**RE: 419 S. Pine Ave
Response to Village Comments
Haeger File No.: 24-042**

Haeger Engineering ("Haeger") is in receipt of your review comments dated April 9, 2024. We have revised the submittal materials accordingly per the comments. The original review comments are included below, shown in *italics*, with our responses to each comment followed in **bold**.

419 S. PINE AVENUE TWO-LOT SUBDIVISION SUBDIVISION IMPROVEMENT PLANS

UTILITY PLAN

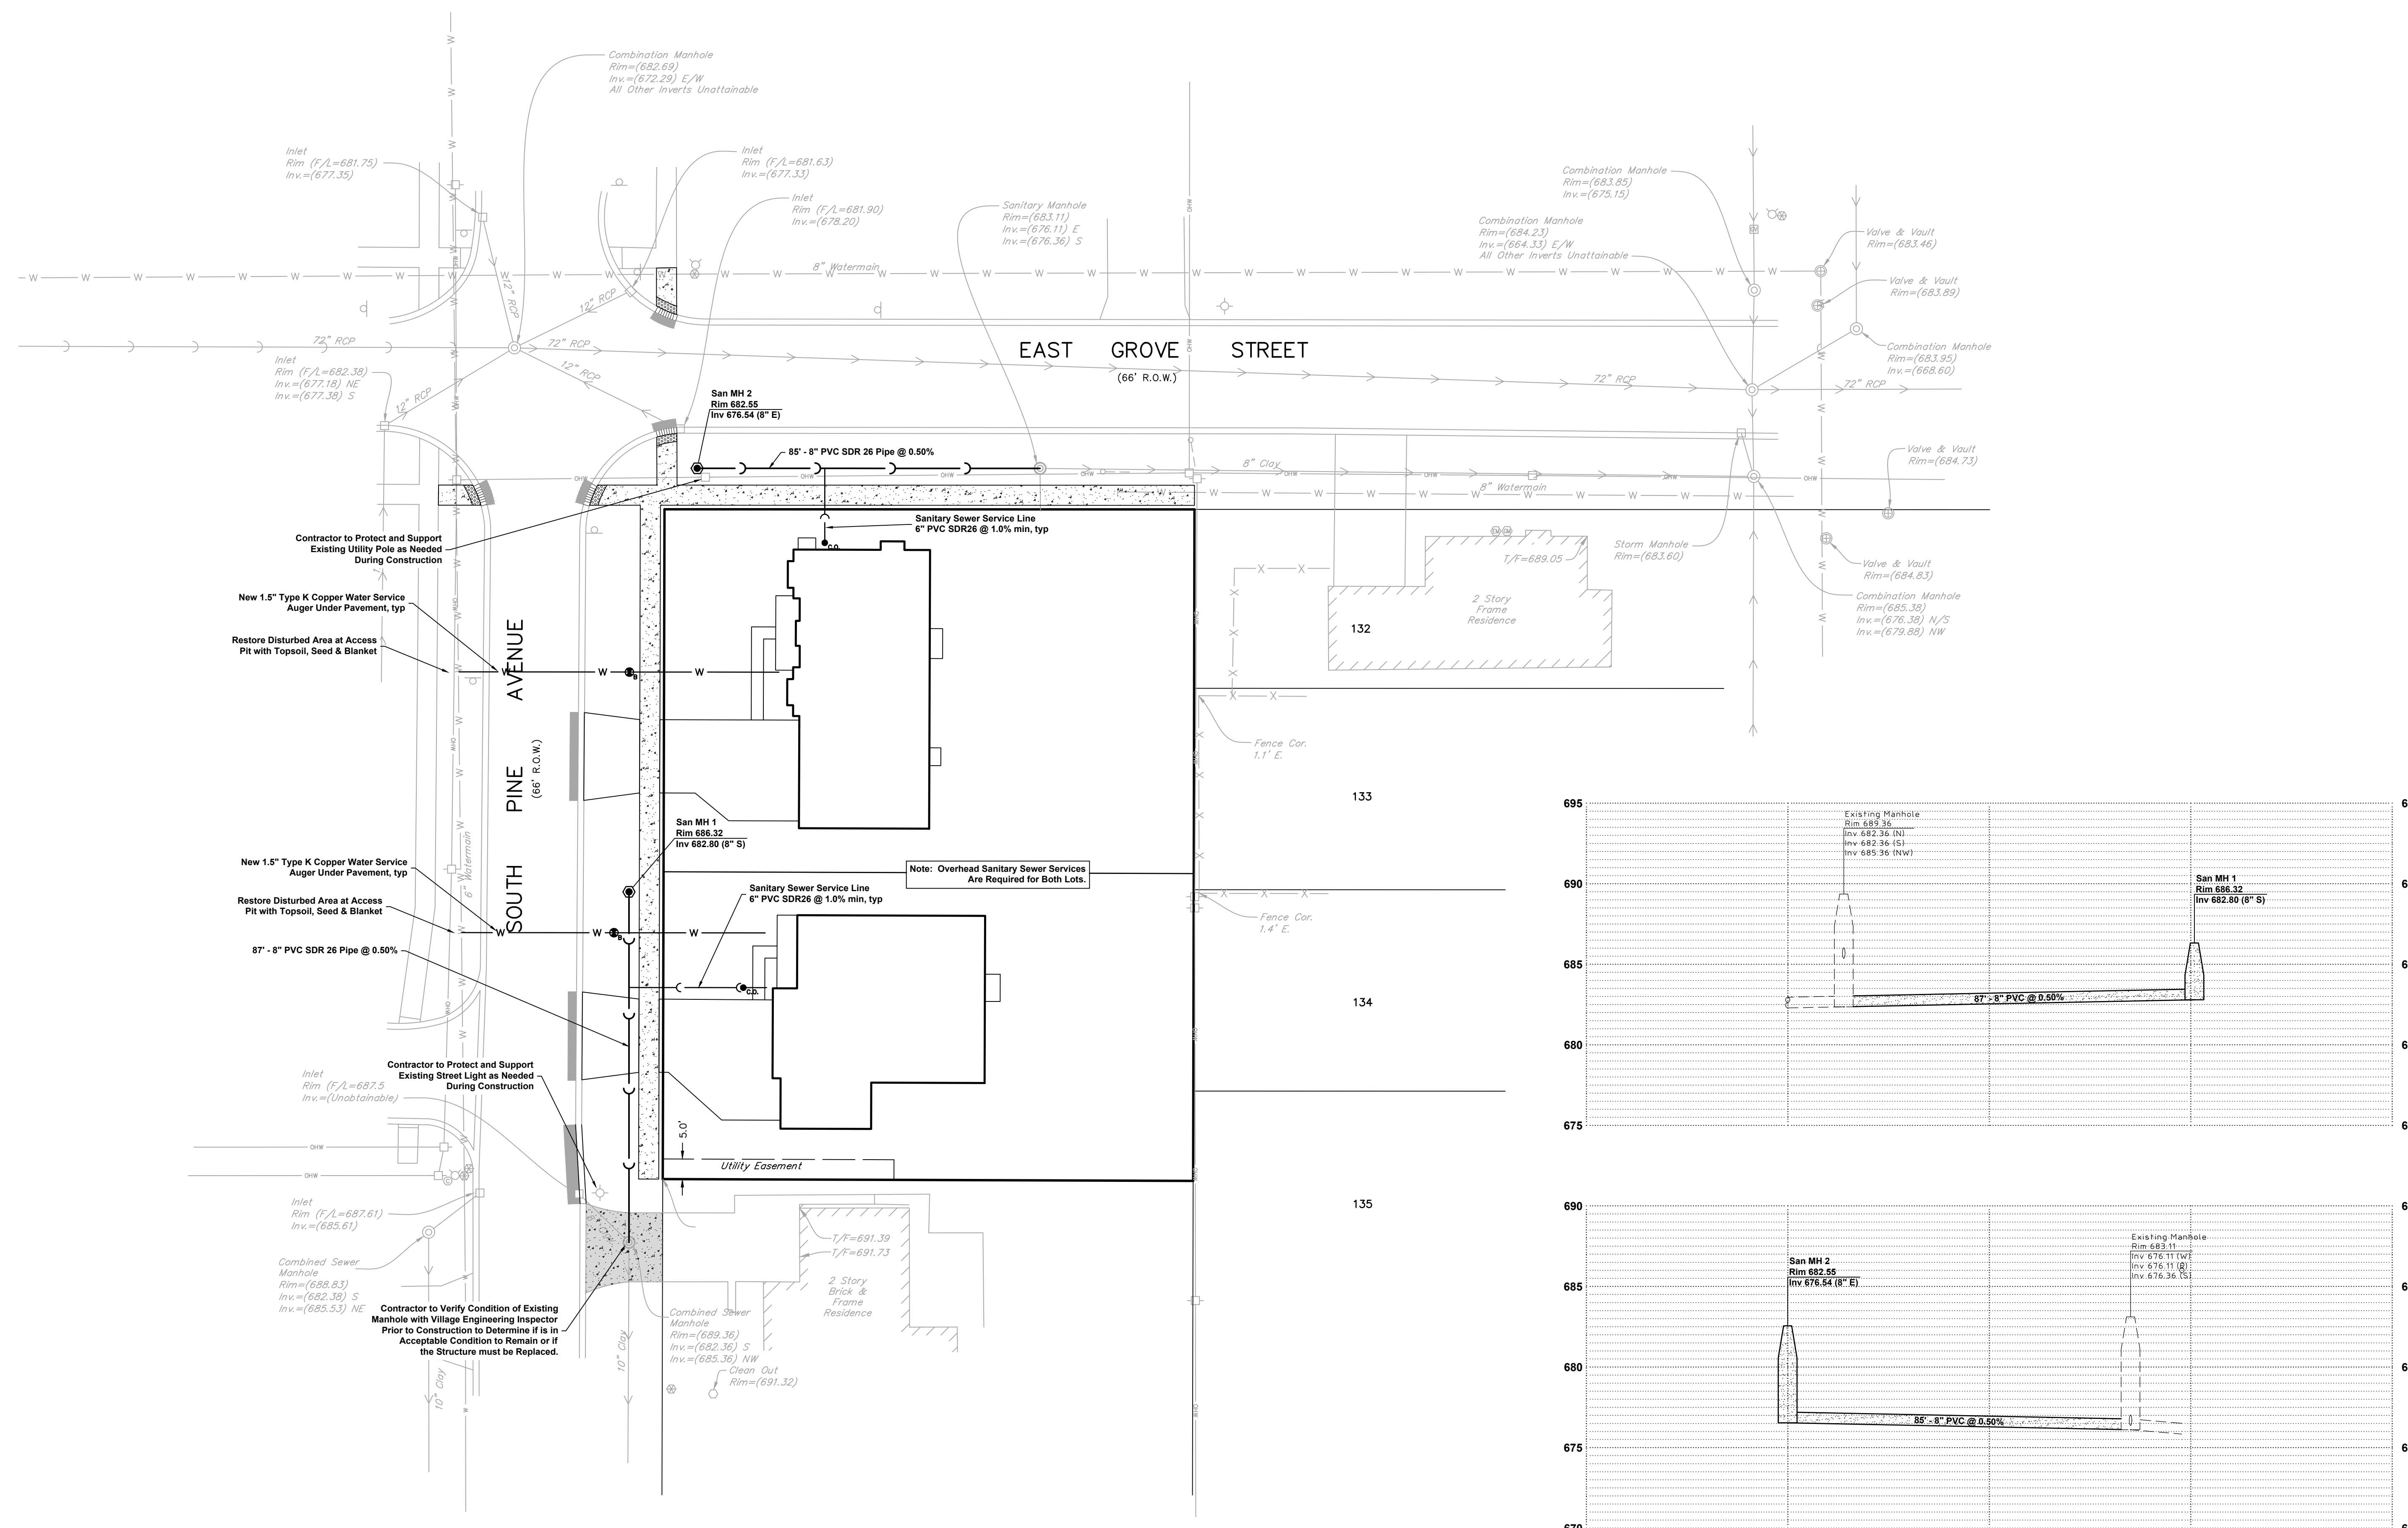
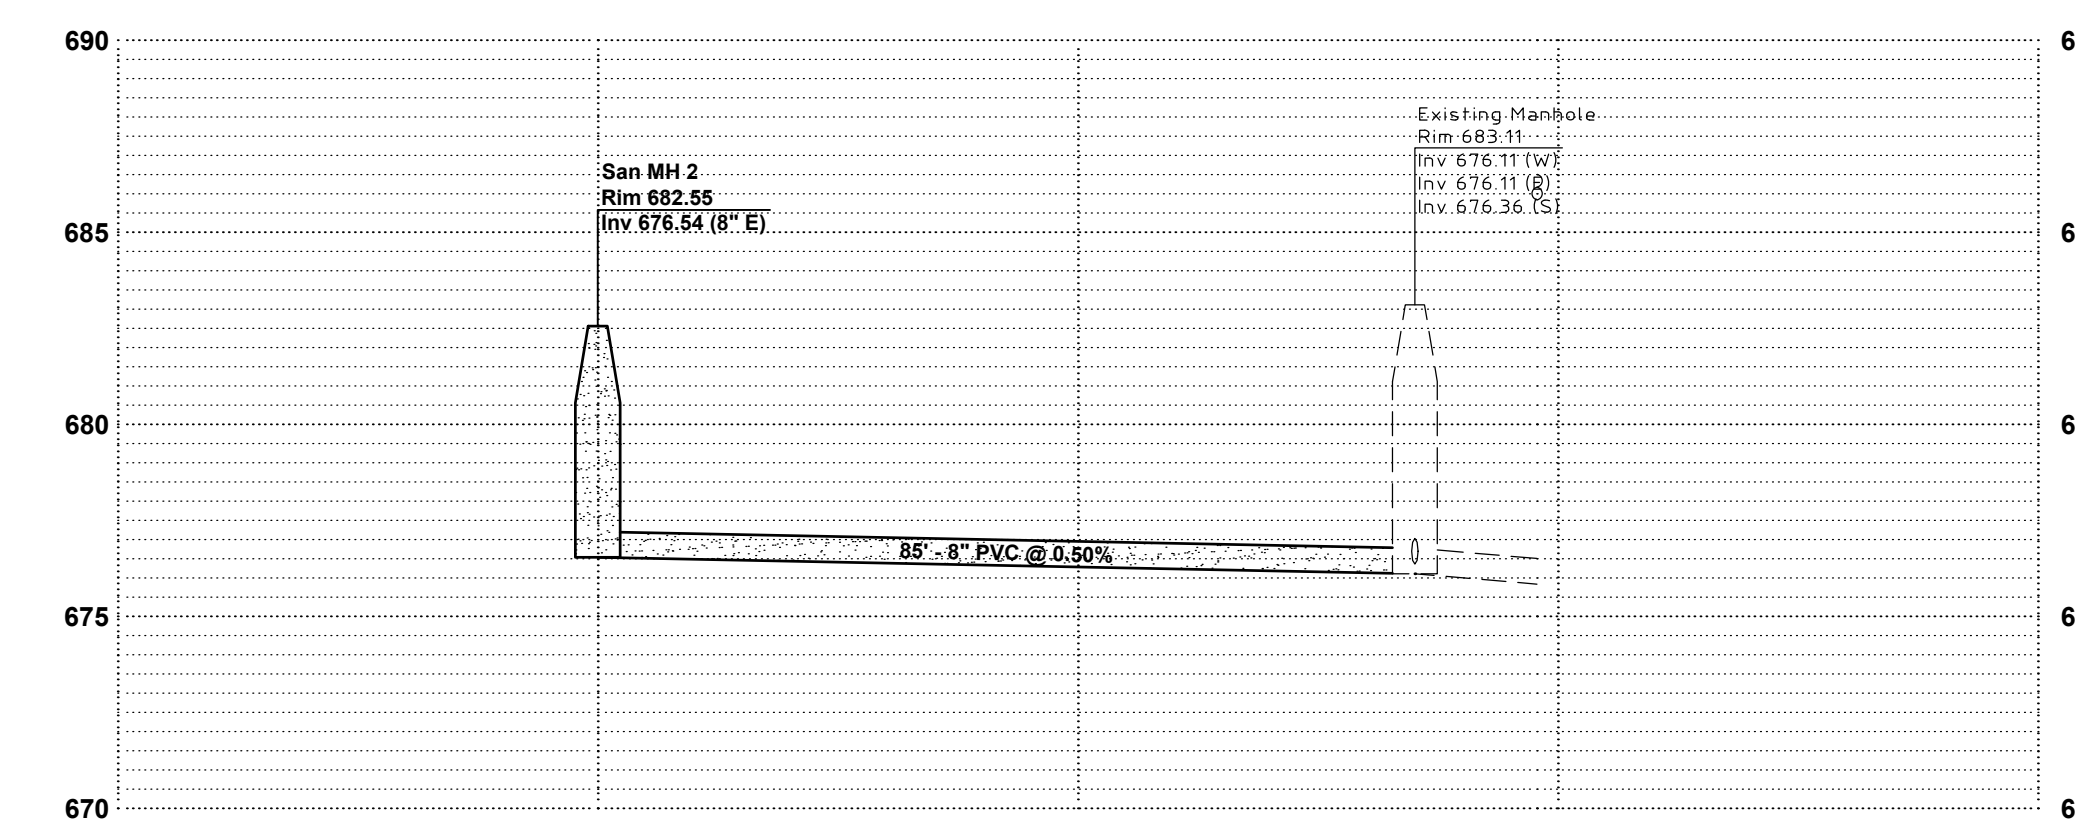
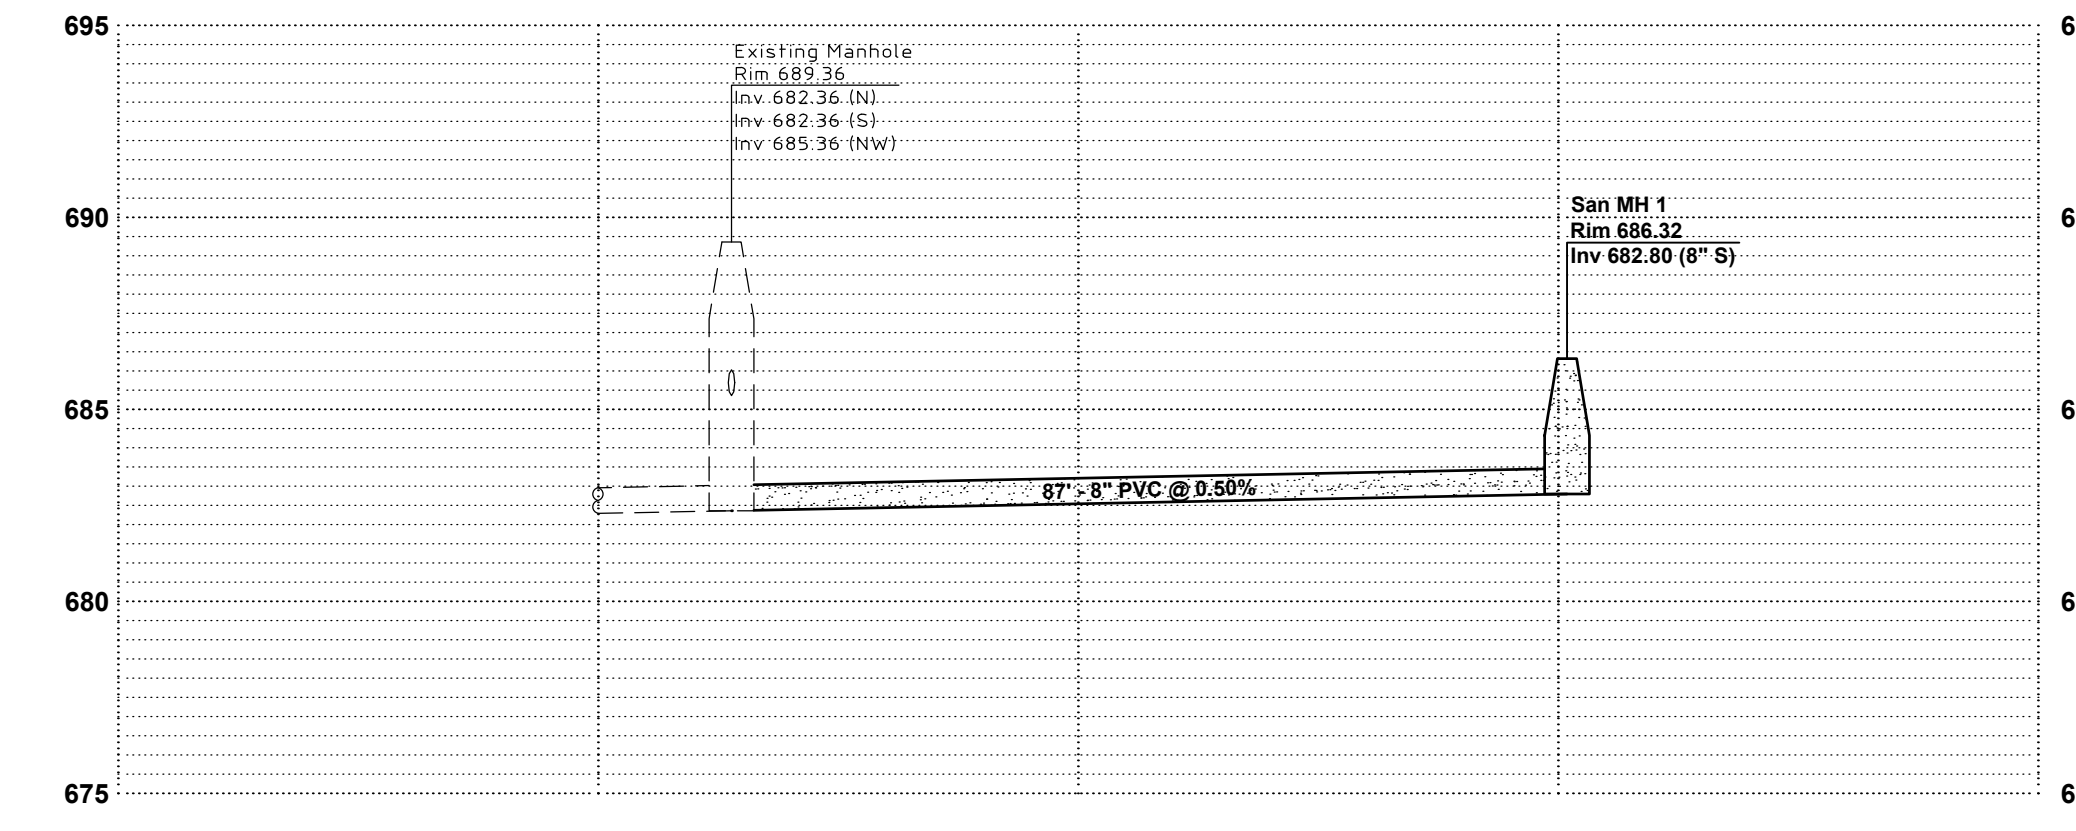
17. Based on the provided grades, the proposed sanitary sewer will not have enough cover to serve the north lot. The 8" sanitary sewer along Grove Street can be extended to serve that lot. The following comments shall be addressed:

a. The existing combined sewer structure is called out as a storm manhole. Correct the structure type on the Engineering plans.

- b. The structure is located in the concrete driveway for 425 S Pine Ave. The driveway shall be removed and replaced from the curb to approximately the property line, to the second joint from the street.*
- c. The condition of the existing structure shall be evaluated before connecting.*
- d. An existing 32" tree is located in the parkway. Identify if this tree is proposed to be removed.*
- e. There is an existing street light located less than 6 ft from the sanitary sewer. The light shall be protected during construction.*
- f. Sanitary sewer extensions shall be across the entire frontage of the lots.*

19. Overhead sewer setup is required for new construction.

The proposed sanitary sewer configuration has been updated in accordance with the review comments above.

Acknowledged, this is noted on Sheet C6.

PAVEMENT PATCHING AT UTILITY TRENCH

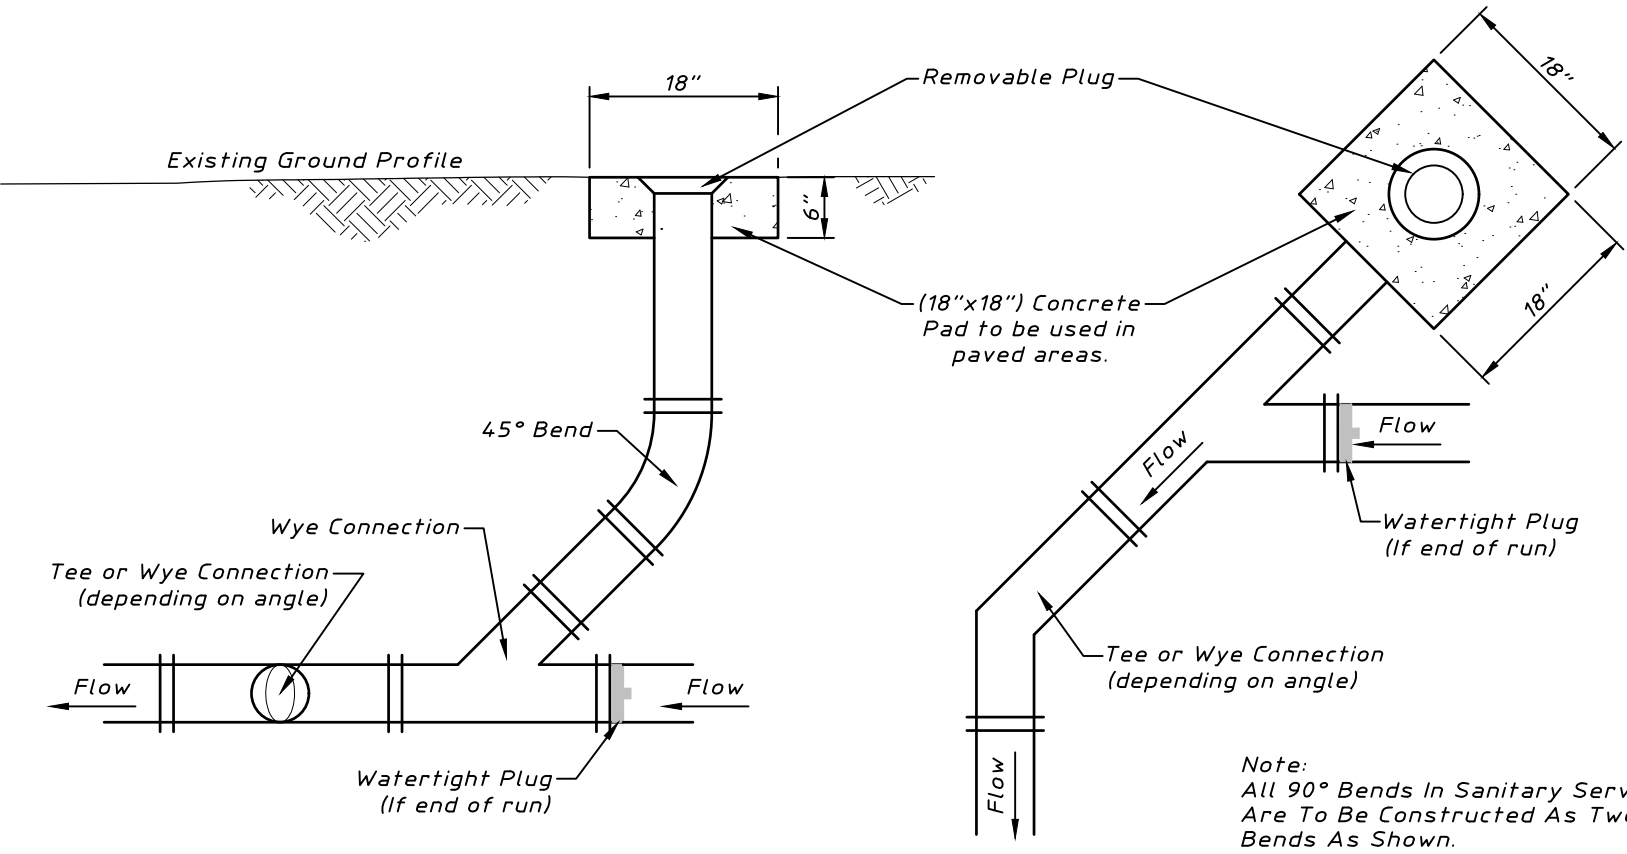
22. Any open cut utility trenches in pavement shall have asphalt ground 2' beyond edge of utility trench for a smooth transition. Provide a detail on the final engineering plans.

This detail has been added to the plan on Sheet C7.
